KS Apparels Ltd.

Bahadurpur, Kaultia, Gazipur
(24.07735N, 90.36604E)

18 May 2014

Observations

Existing structure – 4 & 5 storeys

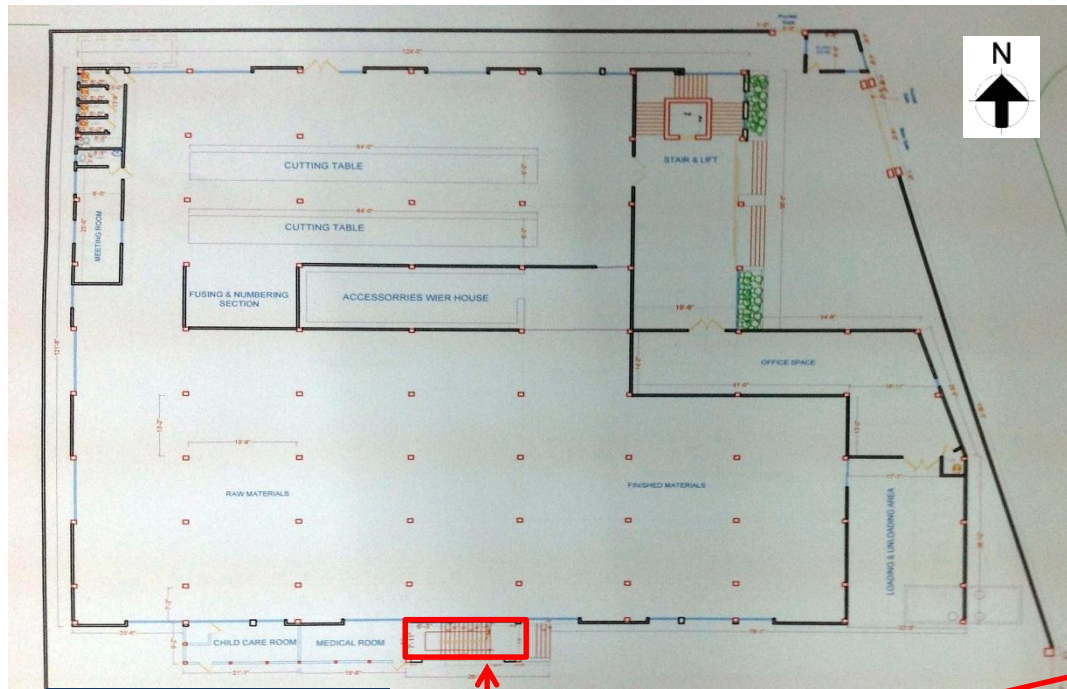
Permit for a total of 7 storeys

Part 4 & 5 storeys currently constructed, permit drawing allows 7 storeys. Building Engineer to review structural design and concrete strength within existing columns prior to commencing construction of any further building extension above the existing.

Item 1 and actions

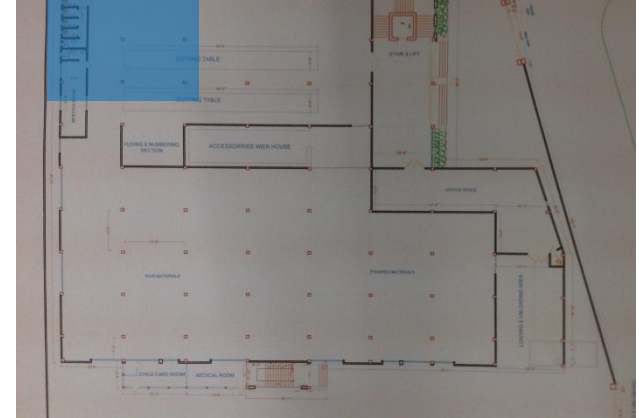
Columns, which support the 5 storey area of the factory, appear to be stressed in excess of normal design limits

- Factory Engineer to review design, loads and column stresses in area identified above.
- Verify insitu concrete strengths (using min. 4 no. 100mm dia. Cores) and existing reinforcement for all columns.
- Produce and actively manage a loading plan for all floor plates within the factory giving consideration to floor capacity and column capacity.

- Continue to implement load management plan
